Groundwater Application Review Summary Form

Application # G- 18787

PUBLIC INTEREST REVIEW FOR GROUNDWATER APPLICATIONS

TO: Water Rights Section Date 6/13/2019
 FROM: Groundwater Section Travis Brown
 Reviewer's Name
 SUBJECT: Application G- 18787 Supersedes review of _____
 Date of Review(s)

Well Location Map

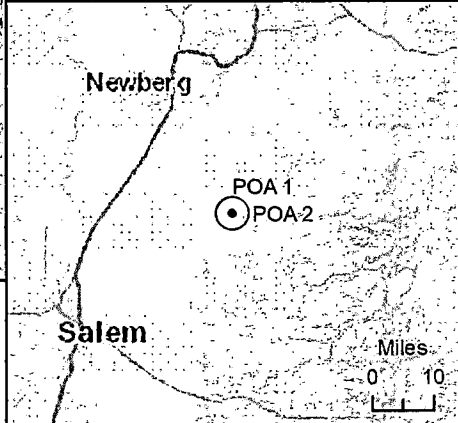
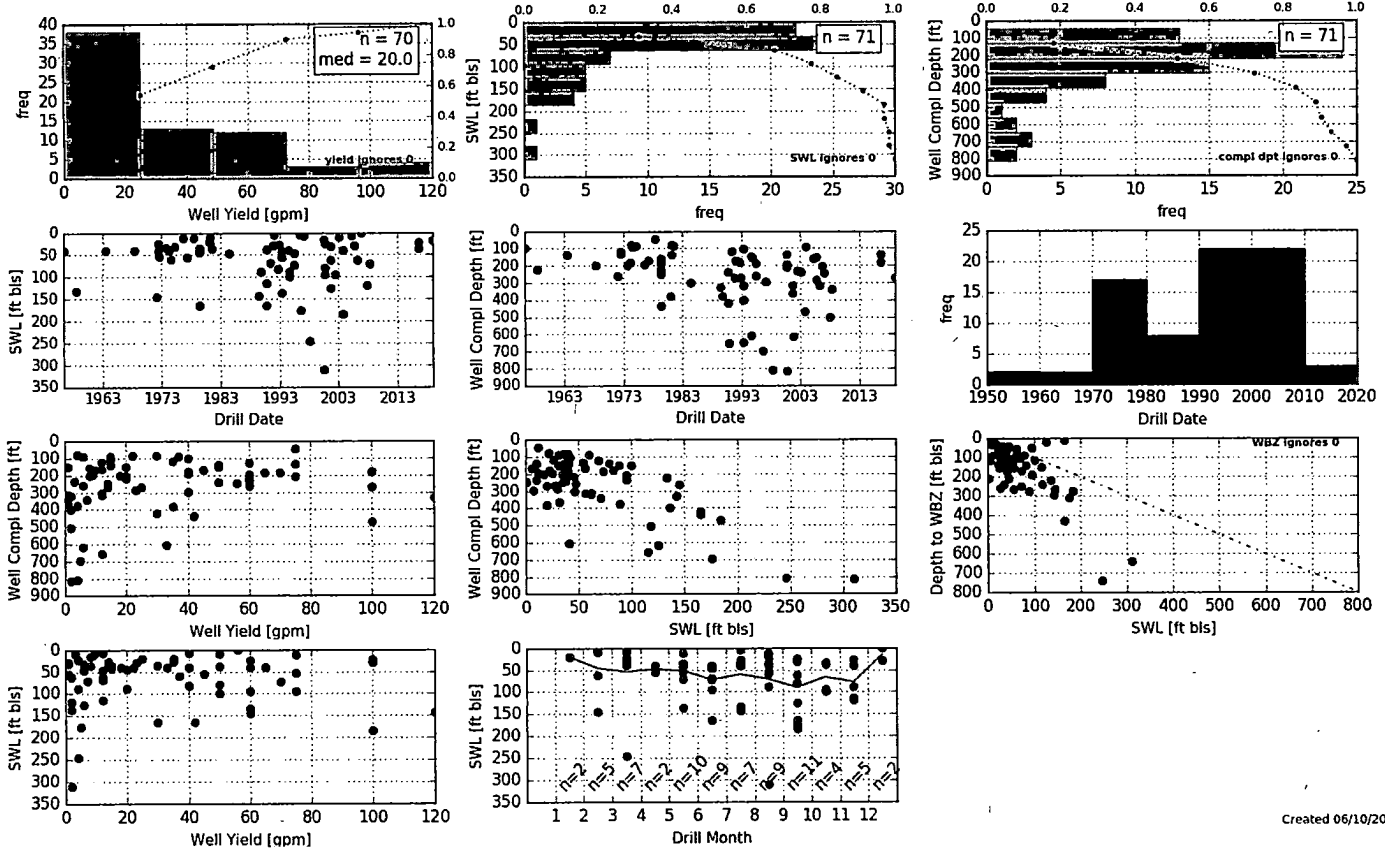
The nearest known groundwater users in the Little Butte Volcanics are greater than 2,500 feet from the proposed POA (see attached Well Location Map). Well-to-well interference could not be quantitatively assessed due to the lack of an appropriate analytical model for the hydrogeology of the Little Butte Volcanics. However, to protect senior users, the conditions specified in B(1)(d)(i), above, are recommended for any permit issued for this application.
